# Rezoning Transportation Analysis

Petition Number: 2020-017

General Location Identifier: Tax ID 11101102

## Revision Log:

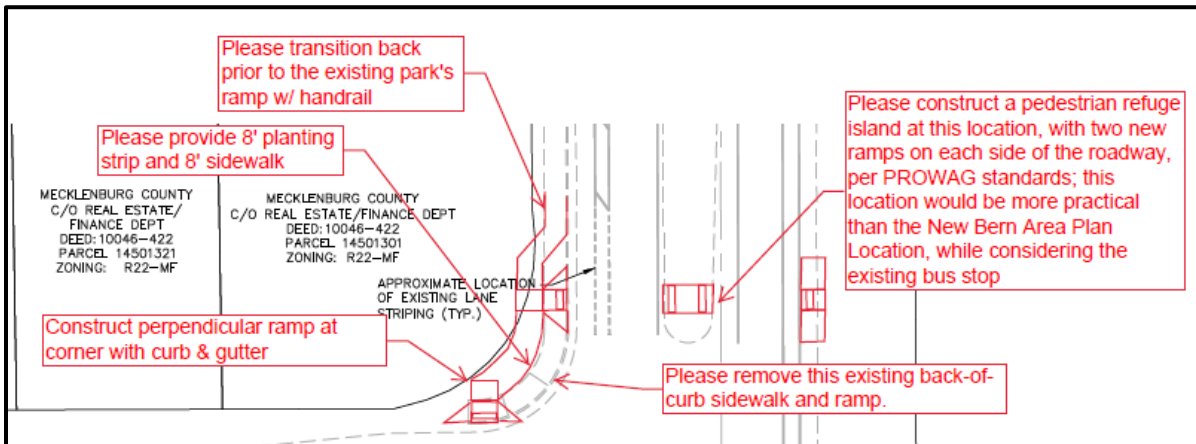
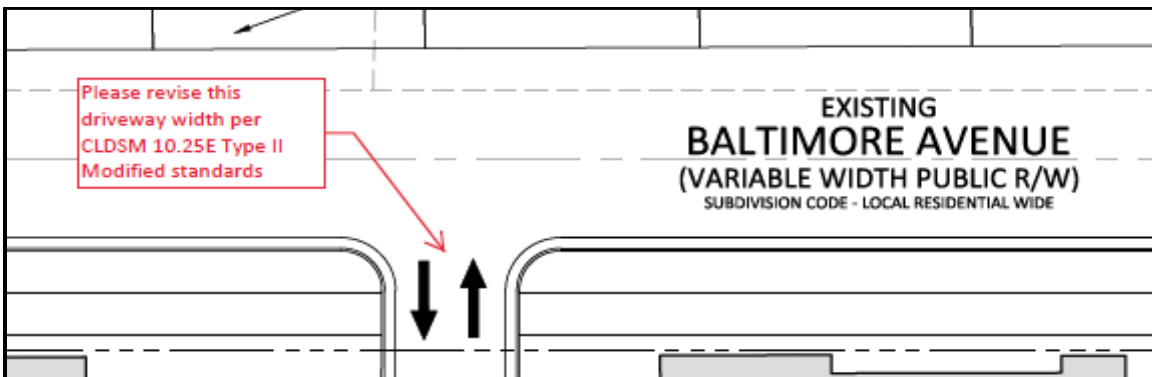
4. ~~Resolved~~ We request the petitioner to revise the site plan and conditional note(s) to construct a pedestrian refuge island across Remount Road, in reference to the Vision Zero Action Plan and enhanced intersection crossing included within the New Bern Area Plan. CDOT has notified Mecklenburg County of the possibility of the petitioner possibly attaining public utility and construction easements to improve the streetscape at this intersection. Please contact Jacqueline McNeil at ([Jacqueline.McNeil@mecklenburgcountync.gov](mailto:Jacqueline.McNeil@mecklenburgcountync.gov)) or (980-314-2511) and Bert Lynn at ([Bert.Lynn@mecklenburgcountync.gov](mailto:Bert.Lynn@mecklenburgcountync.gov)) or (704-589-7491). The pedestrian refuge may be unsignalized, but should still include MUTCD pedestrian crossing signage with a marked crosswalk. Please provide CDOT with an exhibit to review.

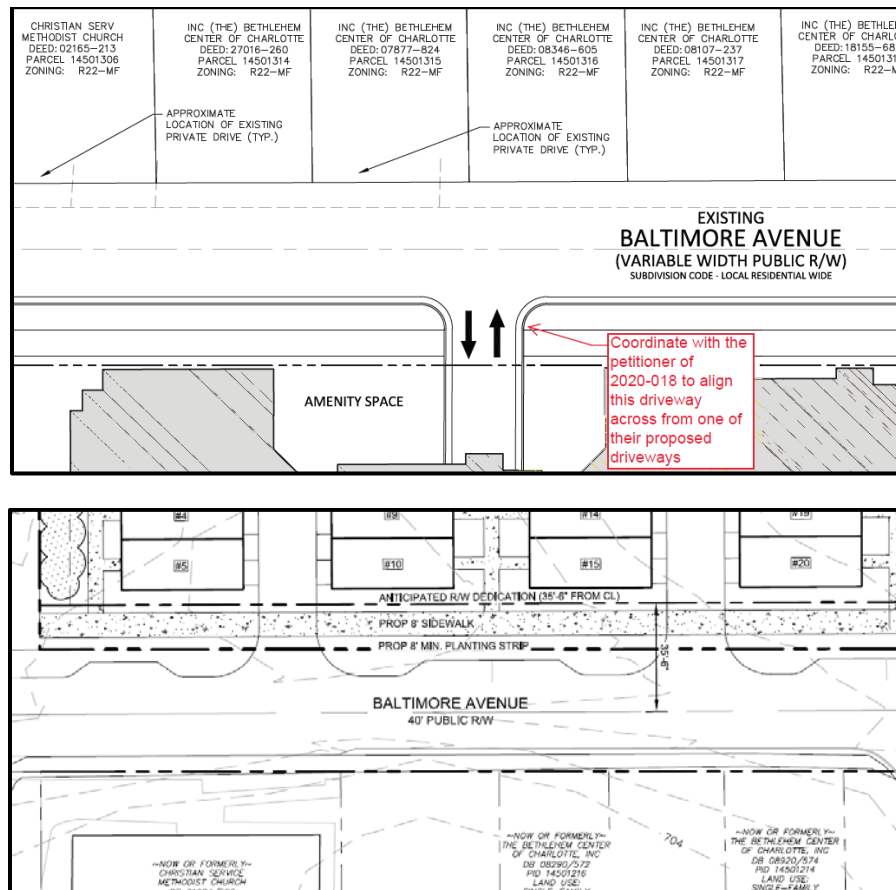
5. ~~Resolved~~ The petitioner is required to revise the site plan and conditional note(s) to widen the proposed access on Baltimore Avenue to a CLDSM standard for two-way traffic.

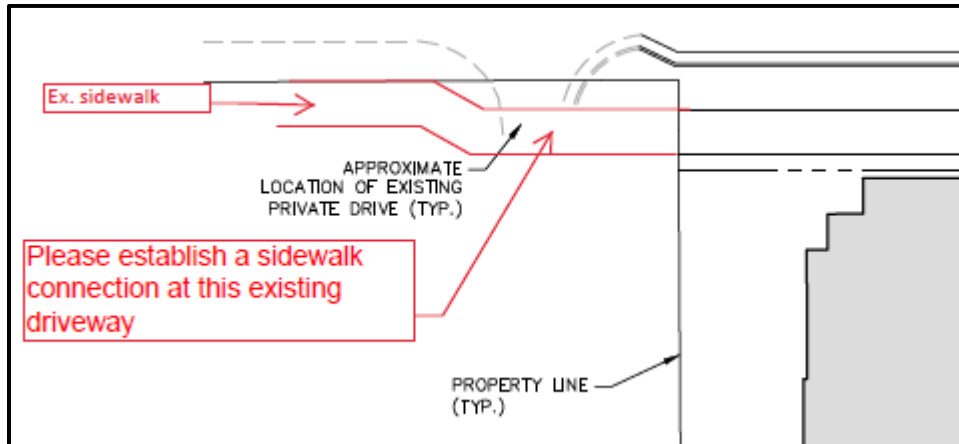
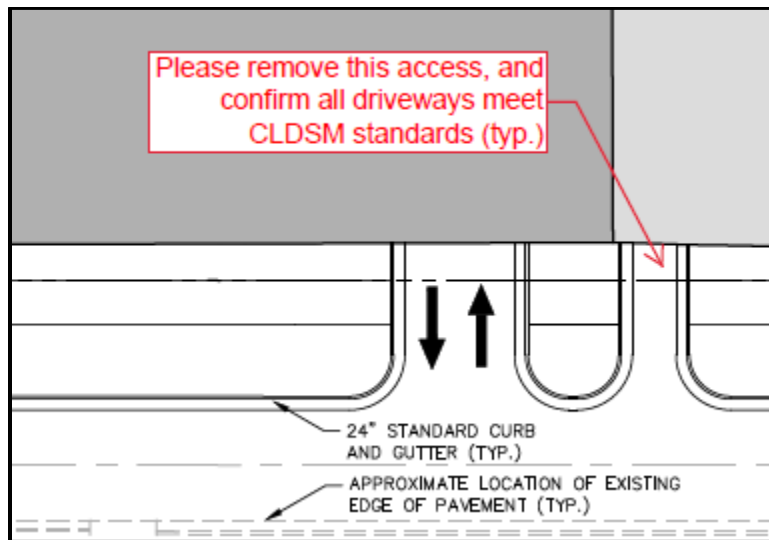
8. **Resolved** The petitioner should revise the site plan and conditional note (Section IV. Transportation, 3) to add specify dedication and fee simple conveyance of ~~all~~ rights of way to the City before the site's first building certificate of occupancy is issued. CDOT requests right of way set at 2' behind back of sidewalk where feasible.
9. **Resolved** The petitioner should revise the site plan and conditional note(s) to remove the proposed access on Norfolk Avenue, as shown below.

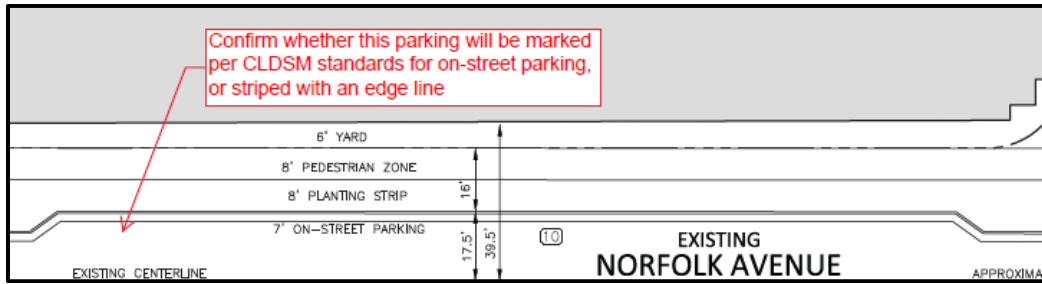
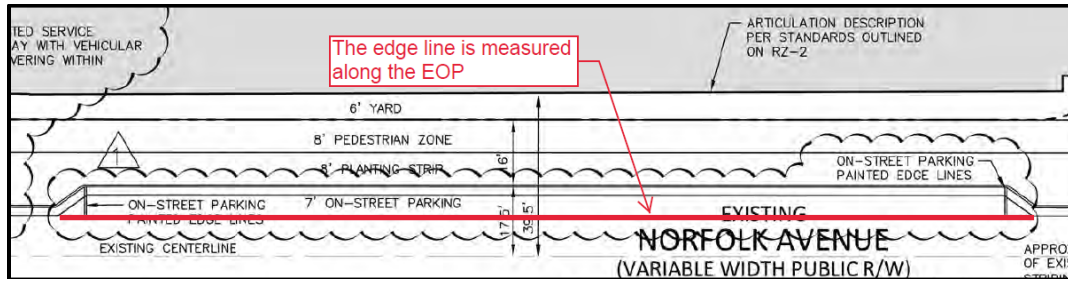
- 14. **Resolved** In reference to the Charlotte BIKES adopted plan and CDOT Streets Map, CDOT requests the petitioner to revise the site plan and conditional note(s) to restripe the area below to replace the existing eastbound right turn lane in favor of extending the buffered bike lane to the intersection of Tryon Street. This request is also supported to establish a constant bike facility connection to the Rail Trail directly into South End.
